Docket Nos.: 50-364
50-348

Joseph M. Farley Nuclear Plant
Response to NRC Safety Audit of the
Service Water Pond Dam on February 2 & 3, 1993

Response to NRC Safety Audit of the
Service Water Pond Dam on February 2 & 3, 1993

FIGURE 1
PLAN OF STORAGE POND
DAM AND DIKE
SCALE: $3/8" = 1' - 0"$

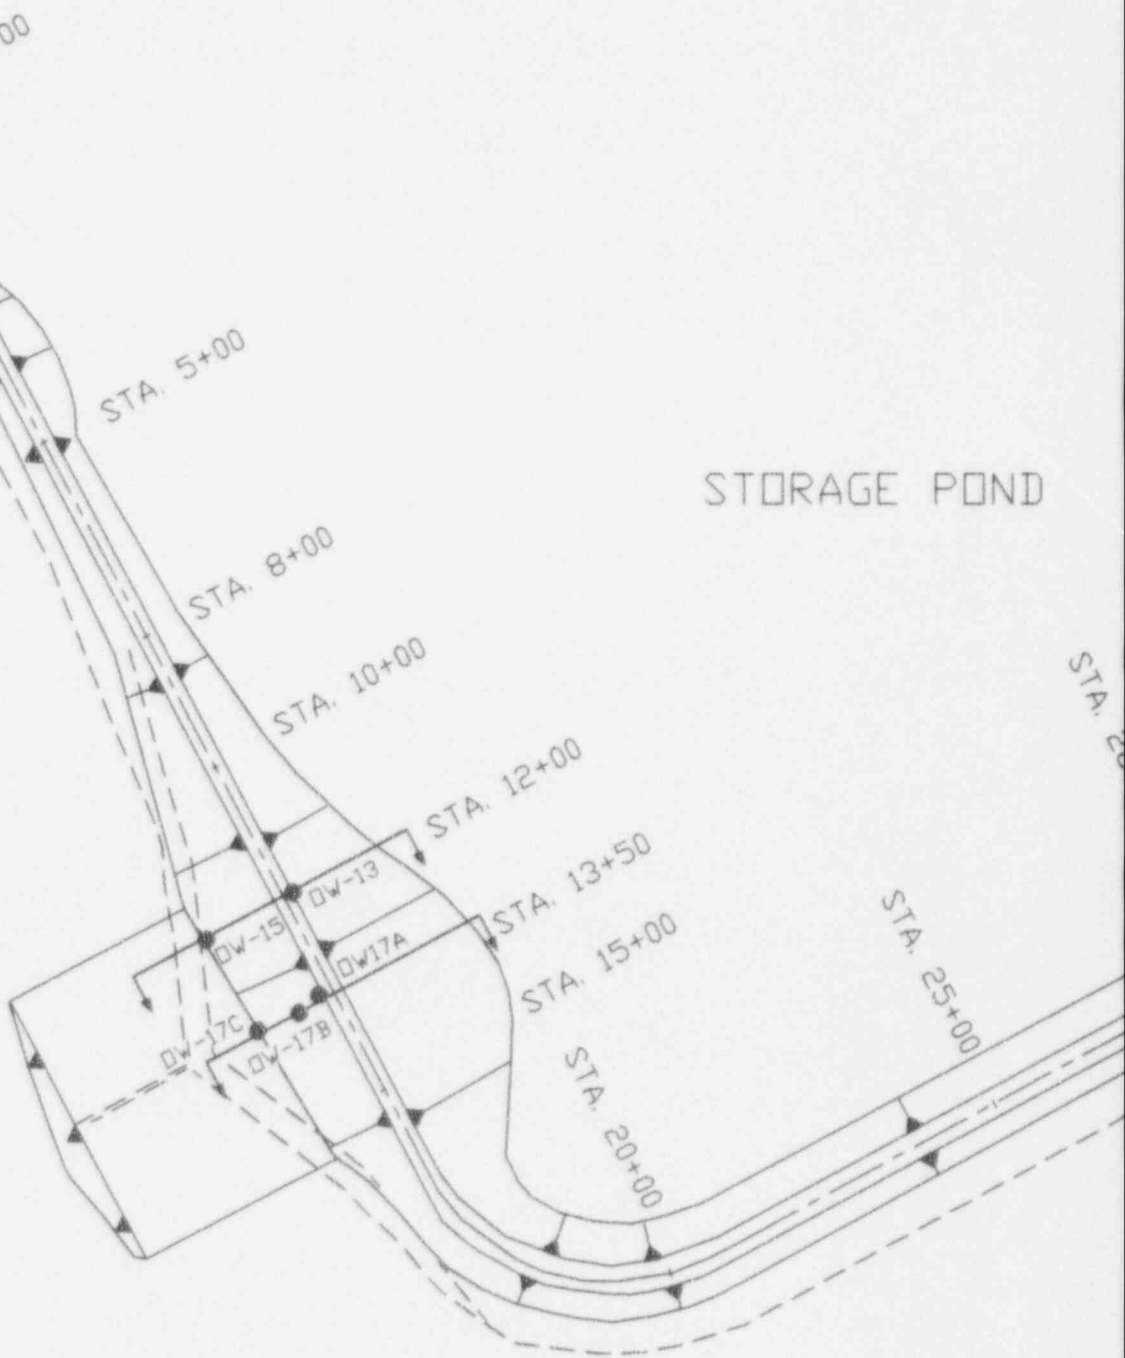
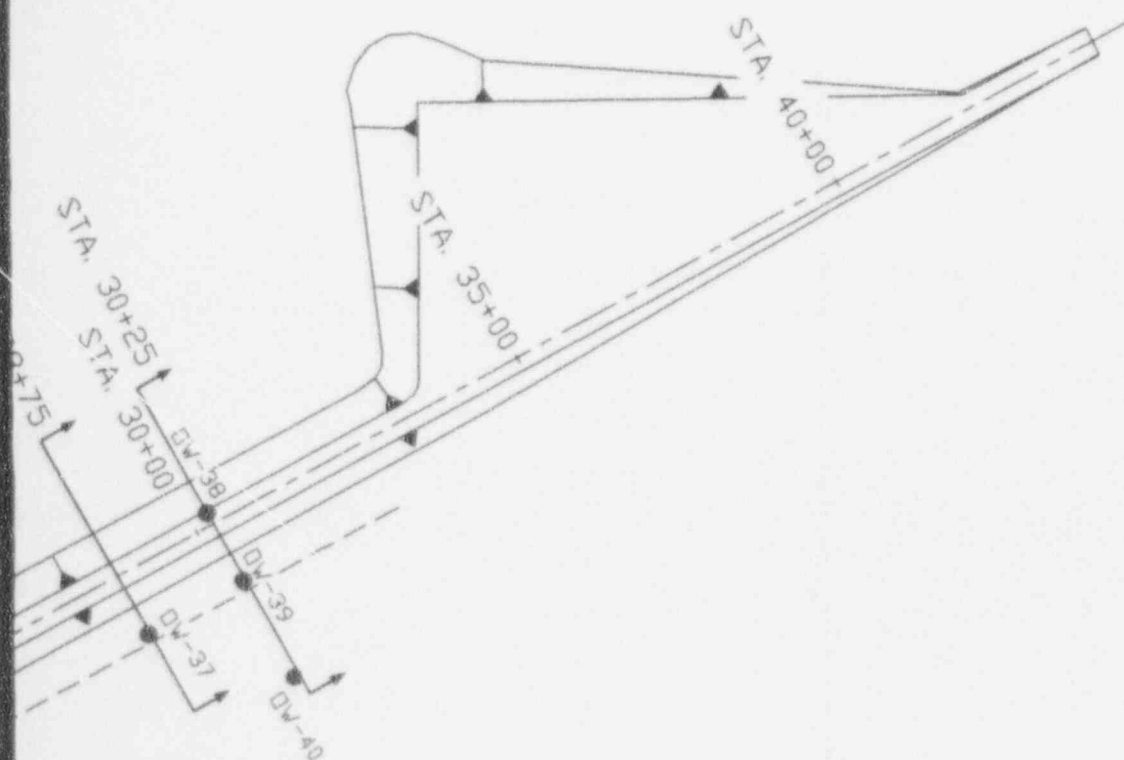
"During the audit, observation wells OW-13 and OW-17C indicated high readings and, after subsequent bailing, the water level returned to the previous high readings. Provide a time-line plot of all data collected from these two observation wells and the observation wells and piezometers adjacent to each of them, since the facility was put into operation by reservoir filling. Clearly indicate on a plan view, such as in the Final Safety Analysis Report (FSAR) Figure 2B7-41, the location of the monitoring points for which data are being provided. For the most recent set of data, plot the water level elevations on a cross section through the embankment at the location of OW-13 and OW-17C that shows the elevations of the chimney drain and the embankment. Also indicate the expected phreatic line and the design envelope phreatic line at the section through each observation well. If the observed phreatic line is outside (above) that considered as the bounding condition used in the analysis of the dam, discuss the impact of the high water levels in the embankment on the safety of the facility. Discuss the possible causes for the increased level of the phreatic line and any additional testing or monitoring that should be considered. Also provide a discussion on the need for additional analyses to reflect the actual observed field conditions."

A plan view showing the storage pond dam and dike and the location of the various observation wells referenced in the following discussion is included as Figure 1.

FIGURE 13
SECTION @ STA. 28+75

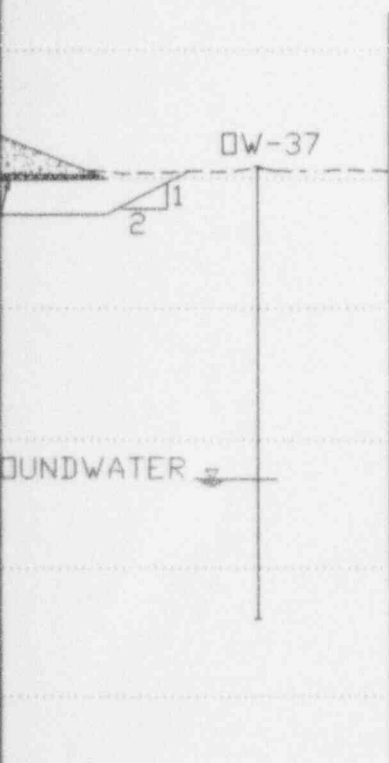
"During the audit, an observation was made that it appears a linear seepage feature has developed near the toe of the embankment in the area between approximately Station 28+75 and Station 30+25. This feature was recognizable from a distance because of the change in color of the vegetation. A close examination revealed that standing water was present, and the presence of hydrophytes indicated the wet conditions to be the normal condition, as opposed to periodic surface ponding from precipitation induced runoff. Provide a time-line plot of all the data from the closest water level or water pressure monitoring instruments since the facility was filled. Clearly indicate on a plan view, the location of the wet area and the adjacent monitoring points. For the most recent set of data, plot the water level elevations on cross sections through the embankment at the location of the monitoring points. Also indicate the design limits of the water surface within the embankment based on the analyses that were completed. Discuss any discrepancies (between the design and actual observed water levels) and the apparent cause(s) for these discrepancies. Provide an evaluation of whether or not there is a need for corrective action, monitoring, etc., relative to this subject. Monitoring should include, as a minimum, mapping the extent of and location of the area, and the inclusion of procedures to review the area on a periodic basis."

As shown on the dam cross-sections, Figures 13 and 14, the most recent phreatic surface through the dam is well below the design phreatic surface at Stations 28+75 and 30+25. Time-line plots for the observation wells in the vicinity including OW-37 through OW-40 indicate that the measured water levels have actually trended downward since pond filling. These factors indicate that the observed wet condition is not due to any reservoir influence.
